HISTORIC AND DESIGN REVIEW COMMISSION

May 16, 2018

HDRC CASE NO: 2018-228
ADDRESS: 114 E RISCHE
LEGAL DESCRIPTION: NCB 2556 BLK A LOT 9
ZONING: RM-4, H
CITY COUNCIL DIST.: 1
DISTRICT: Nathan Historic District
APPLICANT: Gloria Reyes Hilda Salazar
OWNER: Gloria Reyes Hilda Salazar
60-DAY REVIEW:
REQUEST:

114 E Rische

FRONT ELEVATION

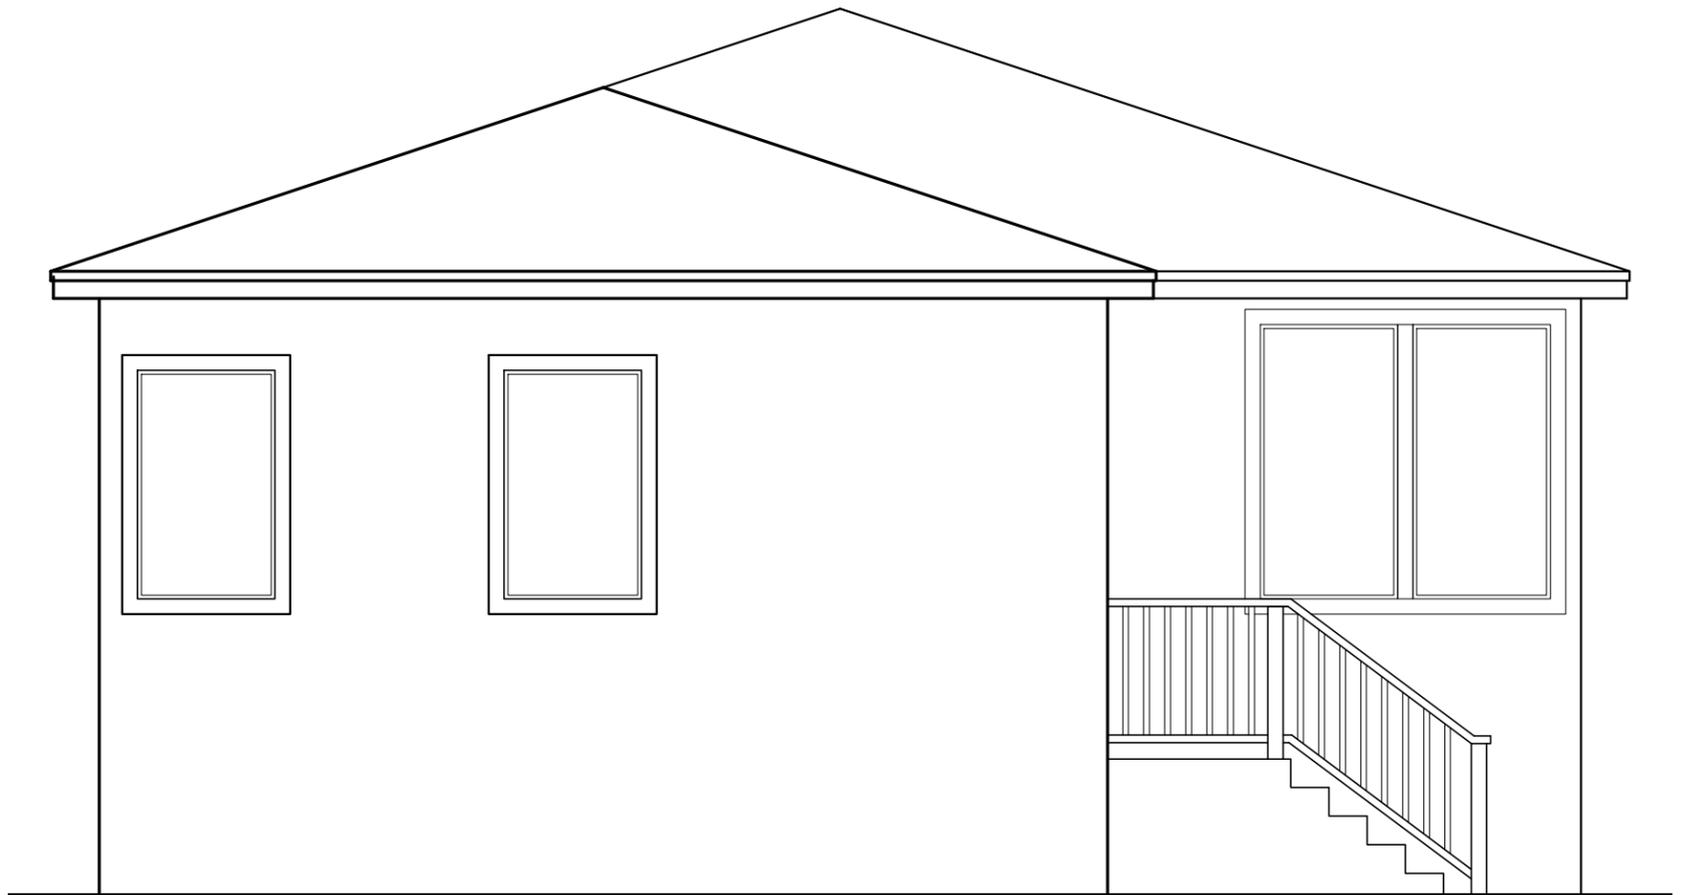
columns. The applicant has proposed Craftsman style columns with both capital and base trim. Staff finds the proposed replacement appropriate. Prior to the issuance of a Certificate of Appropriateness, the applicant is to provide a detailed drawing of the proposed columns that includes dimensions. Columns should feature a width and depth of at least six inches.

- i. Prior to the issuance of a Certificate of Appropriateness, the applicant is to provide a detailed drawing of the proposed columns that includes dimensions. Columns should feature a width and depth of at least six inches.
- ii. That a vertical trim piece be used to differentiate the proposed addition from the existing structure.
- iii. That the proposed wood windows are to feature a profile and installation depth that matches those found on the historic structure.

REAR ELEVATION

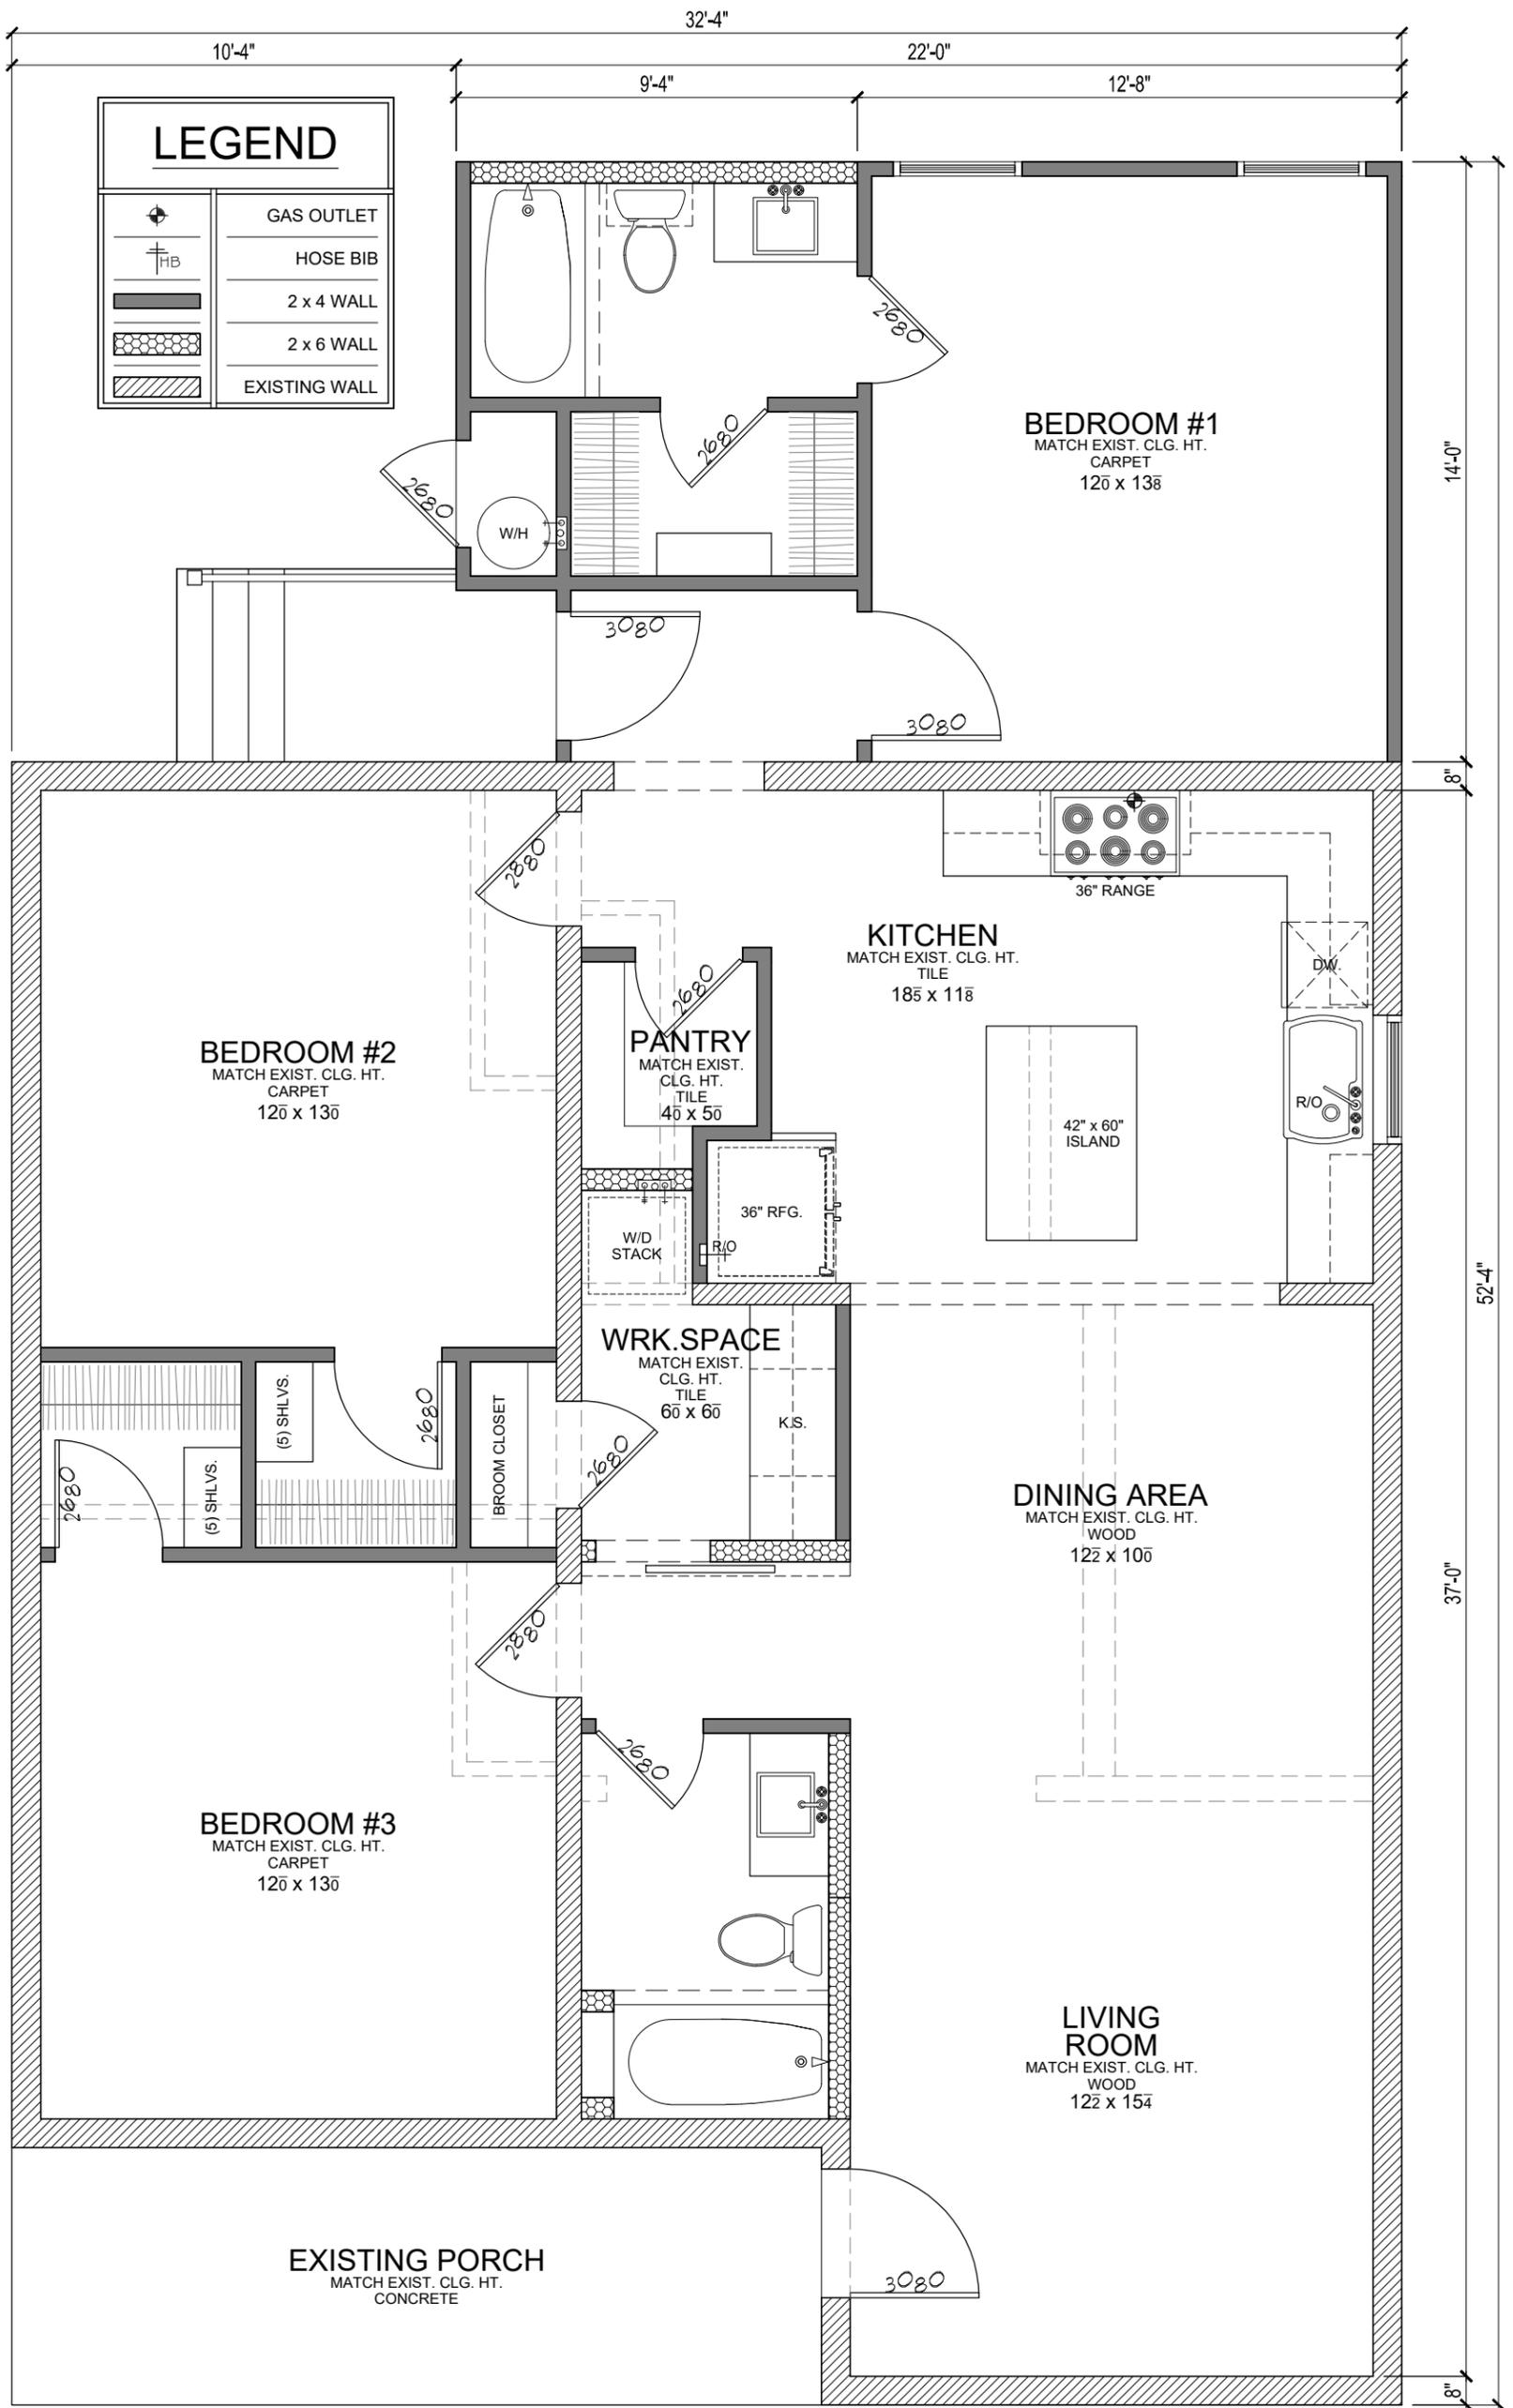
- c. **ADDITION** – At the rear of the primary historic structure, the applicant has proposed to construct a rear addition. The Guidelines for Additions 1.A. states that additions should be sited to minimize visual impact from the public right of way, should be designed to be in keeping with the historic context of the block, should utilize a similar roof form and should feature a transition between the old and the new. The applicant has proposed for the addition to include a hipped roof to be subordinate to that of the primary historic structure's. The applicant has not proposed an inset in the wall plane at this time. Staff finds that a vertical trim piece should be used to differentiate the proposed addition from the existing structure.

- d. **SCALE, MASS & FORM** – Regarding scale, mass and form, the applicant has proposed for the rear addition to feature an overall roof height that is subordinate to that of the primary historic structure and a footprint that is consistent with the Guidelines.

- e. **MATERIALS** – The applicant has proposed materials that include wood siding and wood windows to match those found on the historic structure as well as an asphalt shingle roof. Staff finds the proposed materials to be appropriate and consistent with the Guidelines. The proposed wood windows are to feature a profile and installation depth that matches those found on the historic structure.
